# PLANNING APPLICATION FOR THE EXPANSION OF A MATERIALS RECOVERY FACILITY AT CAPPOGUE AND DUNSINK, BALLYCOOLIN ROAD, DUBLIN 11.

## Response to Request for Further Information

**Abstract:** This report contains the response to a Request for Further Information (RFI) in connection with planning case number ABP-315257-22 for development at Cappogue and Dunsink, Dublin 11.

**Figure 1:** Existing Runoff Sources into the M50 Culvert

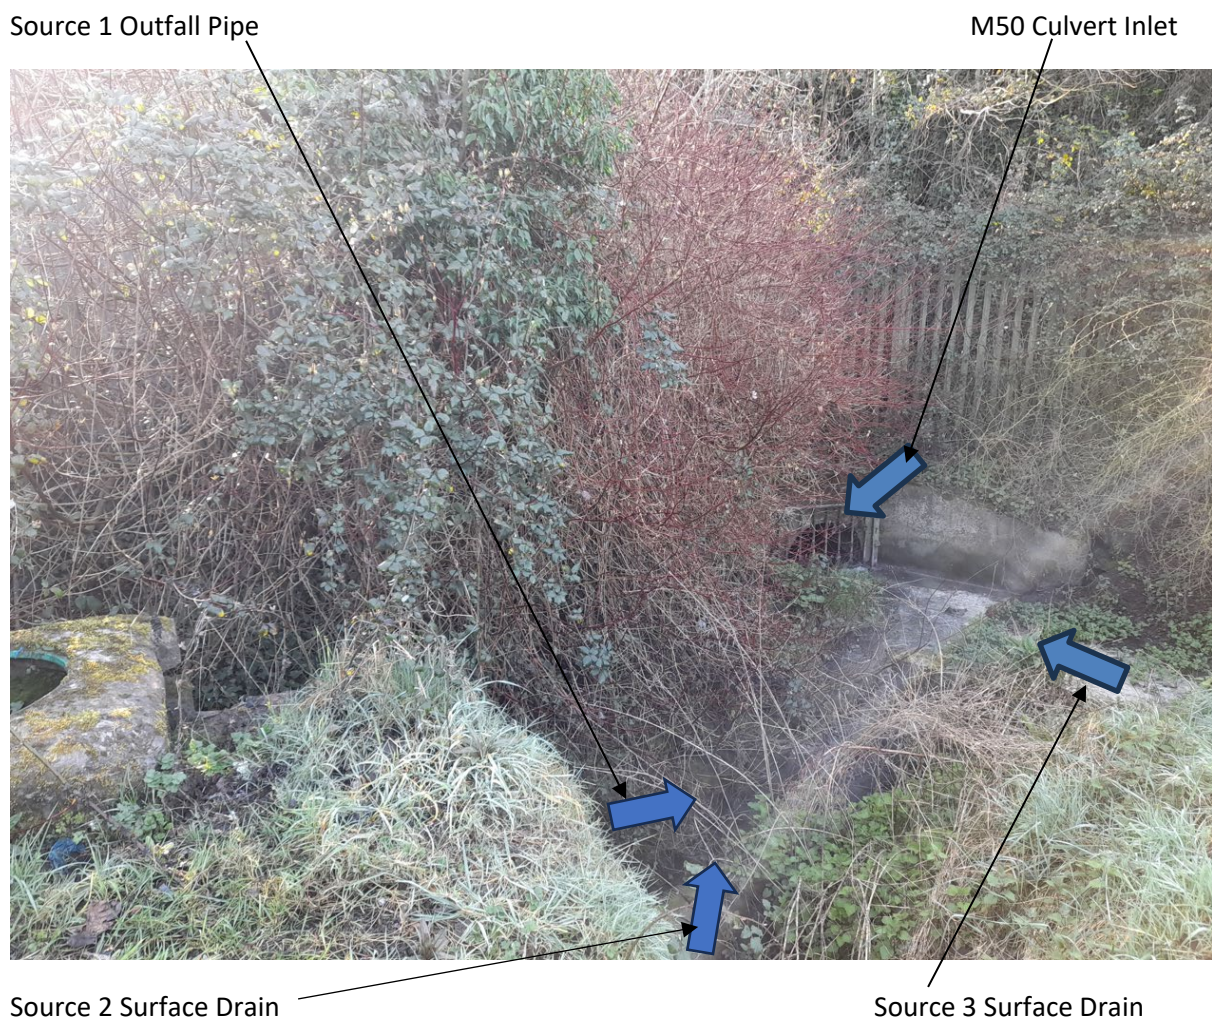
On 06/10/2023 TII Land Use Planning issued a letter response via email and is included in Appendix 3. TII requested clarification in regard to the structural condition of the M50 culvert, the potential impact of the concrete lining and the potential impact of any exceedance flow on the culvert.

Figure 1 shows the locations of respective surface water runoff sources immediately upstream of the M50 culvert. Existing services upstream of the M50 culvert are shown in Drawing P21-150-0700-0002 RevB Existing Services which is enclosed.

| PROJECT                                                                 |  | CLIENT              |                   |               |
|-------------------------------------------------------------------------|--|---------------------|-------------------|---------------|
|                                                                         |  | CS                  | P21-150-0700-0003 | B             |

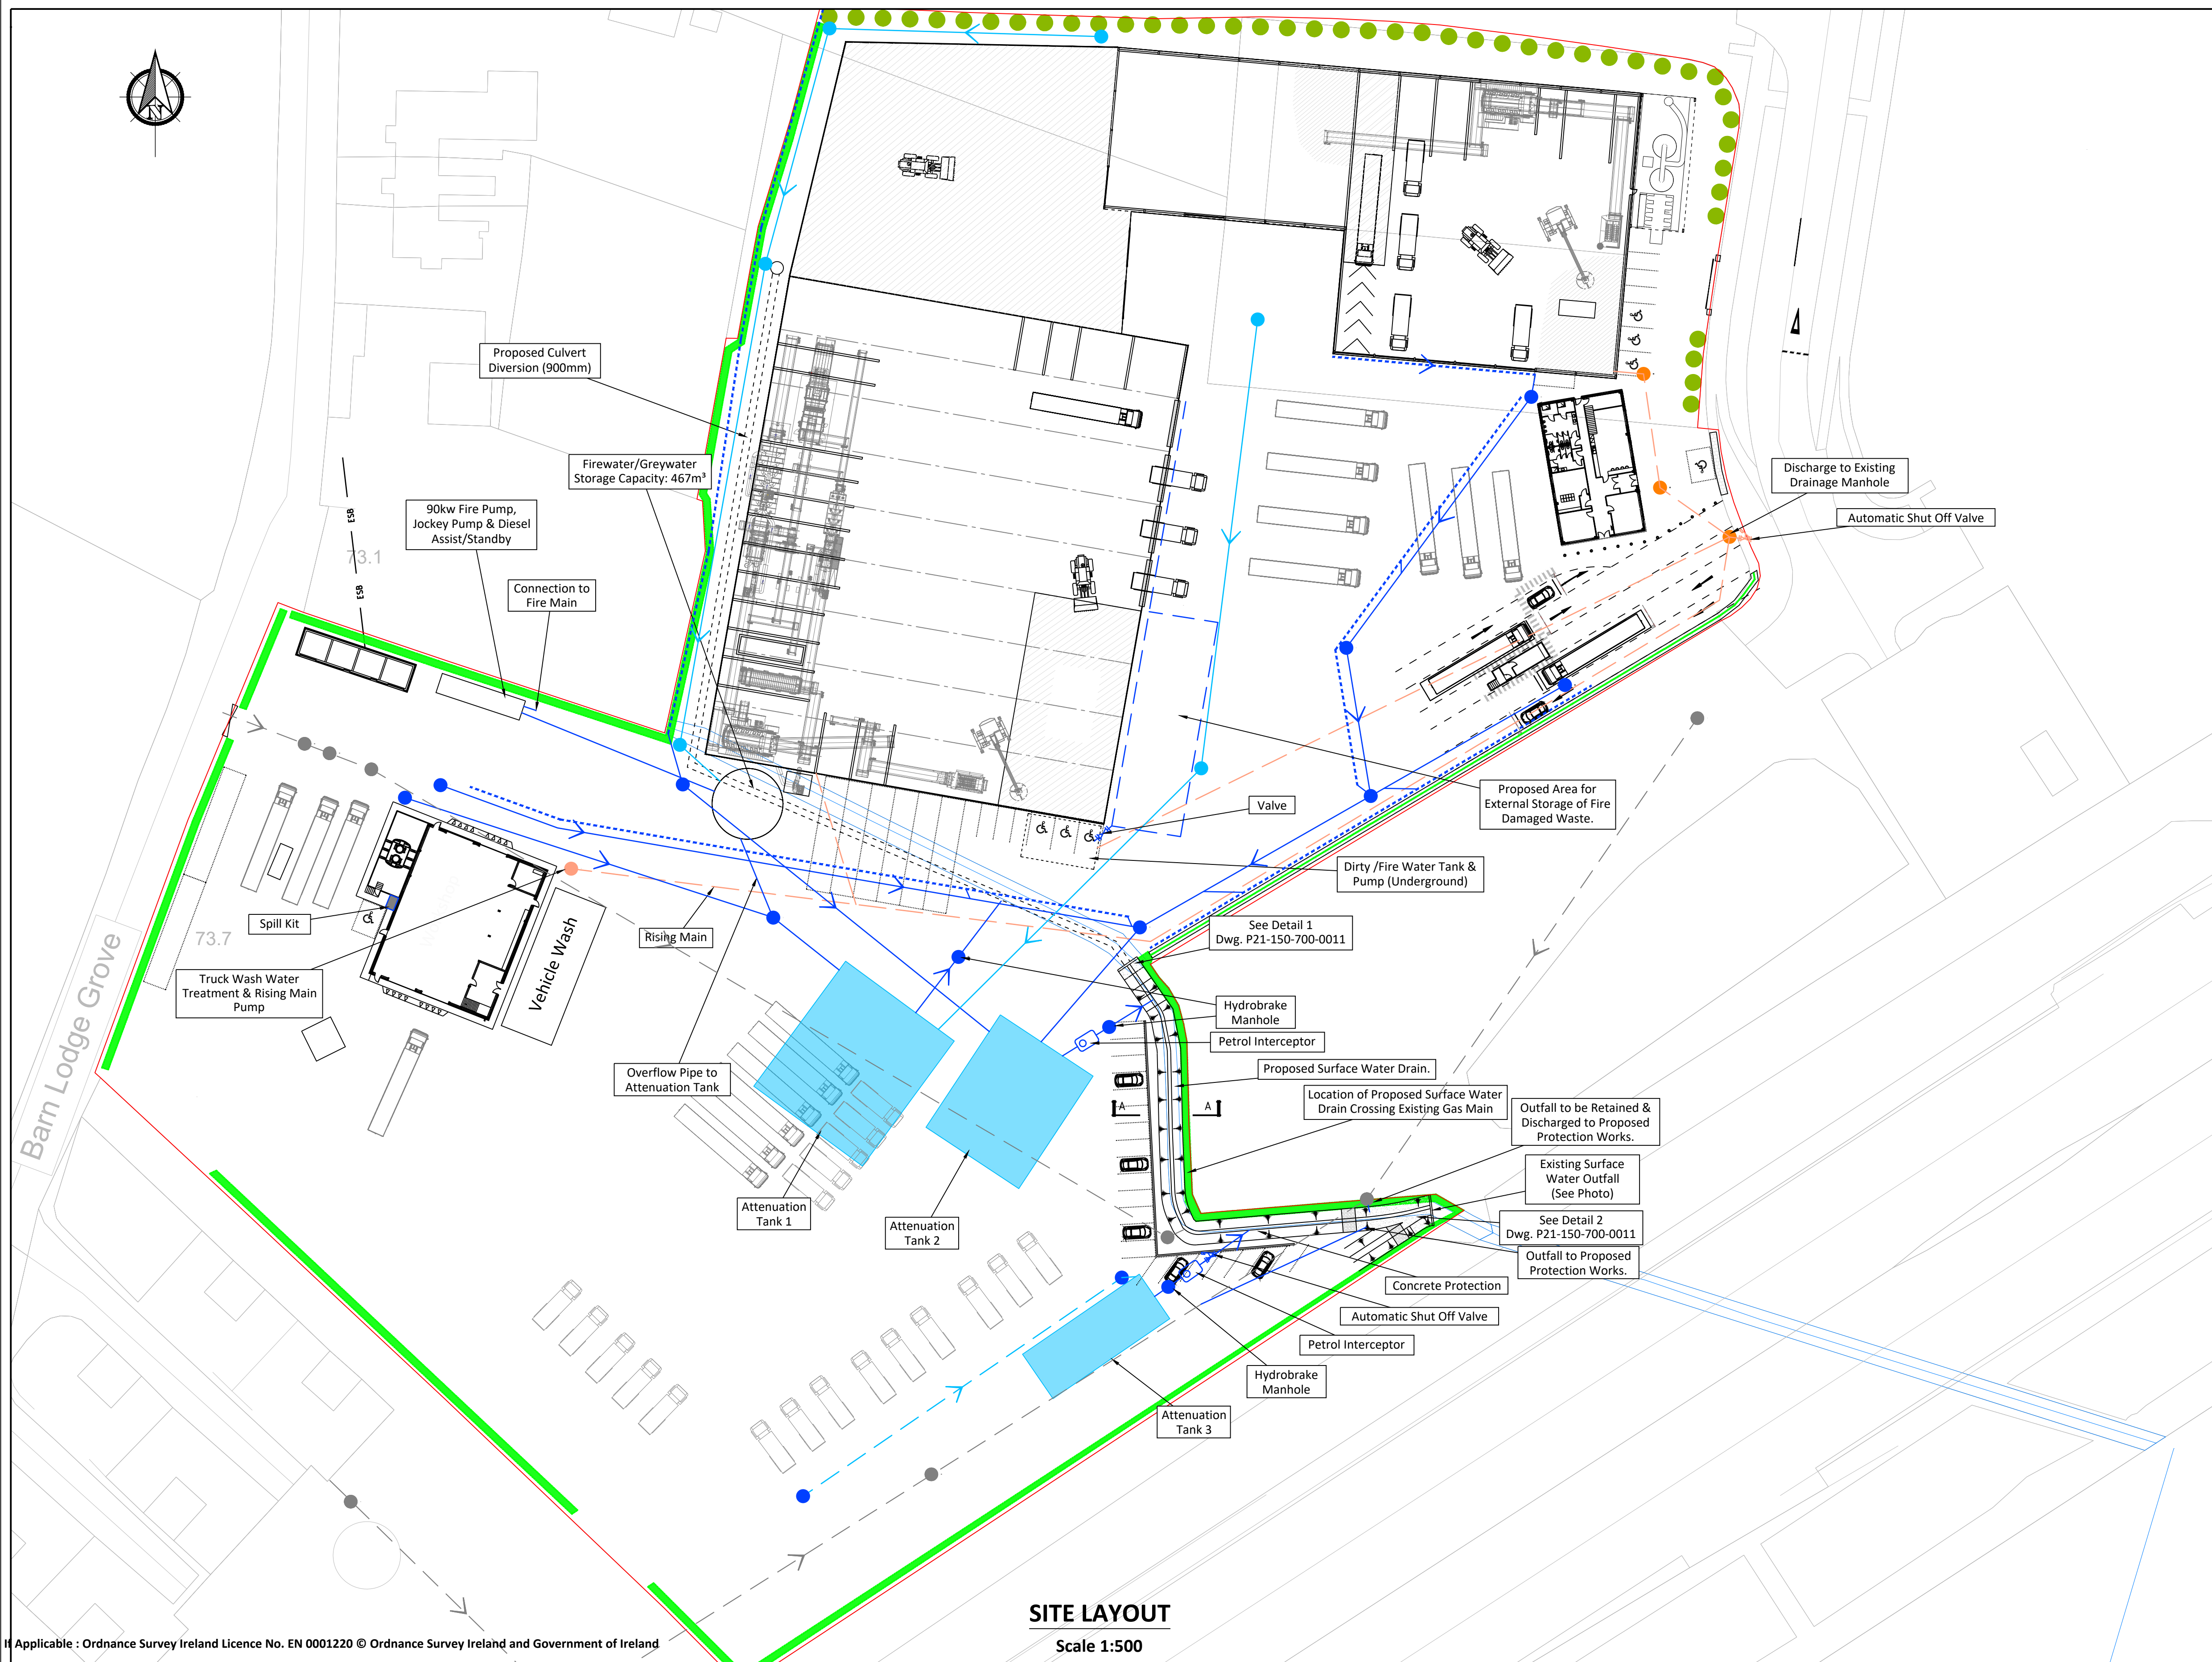
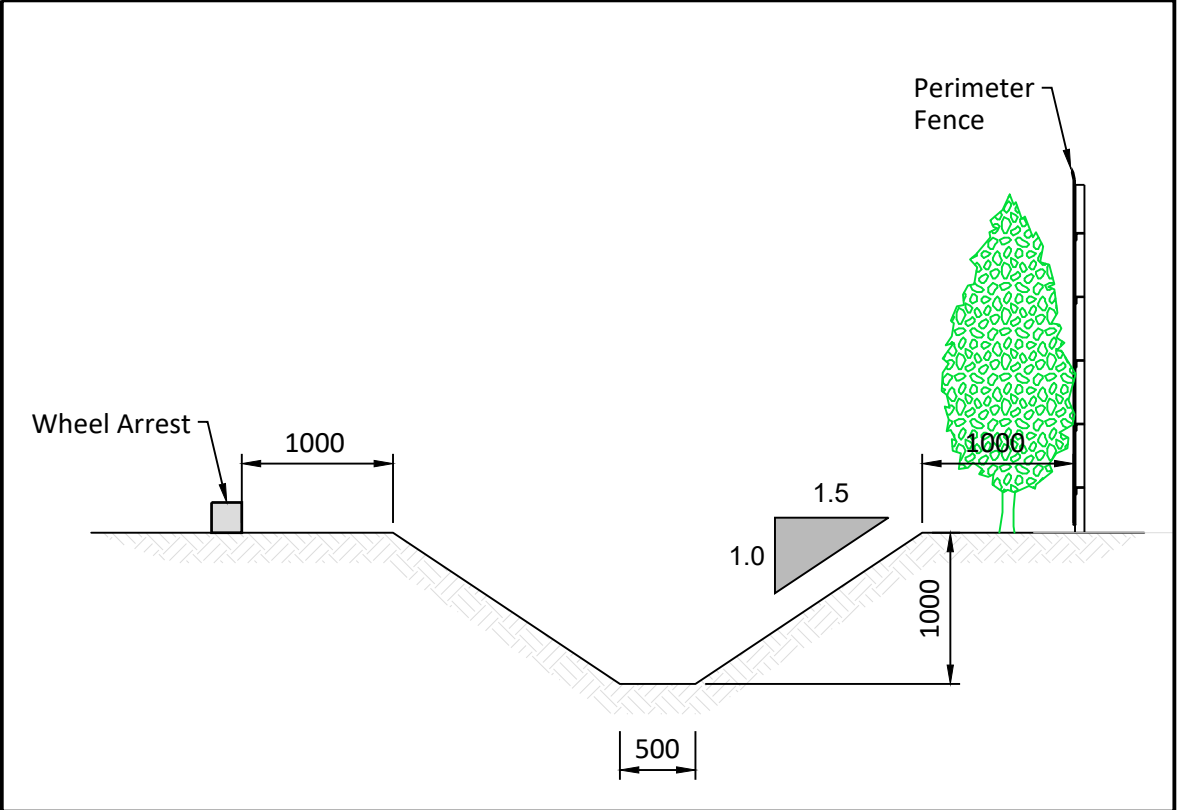
The TII, in its submission, dated 20th January 2023, require a specific review of the potential impact on the M50 culvert and that appropriate mitigation should be undertaken in consultation with TII's Structures Section. The response should be supported by revised drawings and documentation for both construction and operation phases of the proposed development.

The proposed protection works upstream of the M50 culvert are shown in Drawing P21-150-0700-0003 RevB Proposed Services – Surface and Foul Water Drainage which is enclosed. Surface water outfalls from the proposed drainage system discharge into the existing M50 culvert.
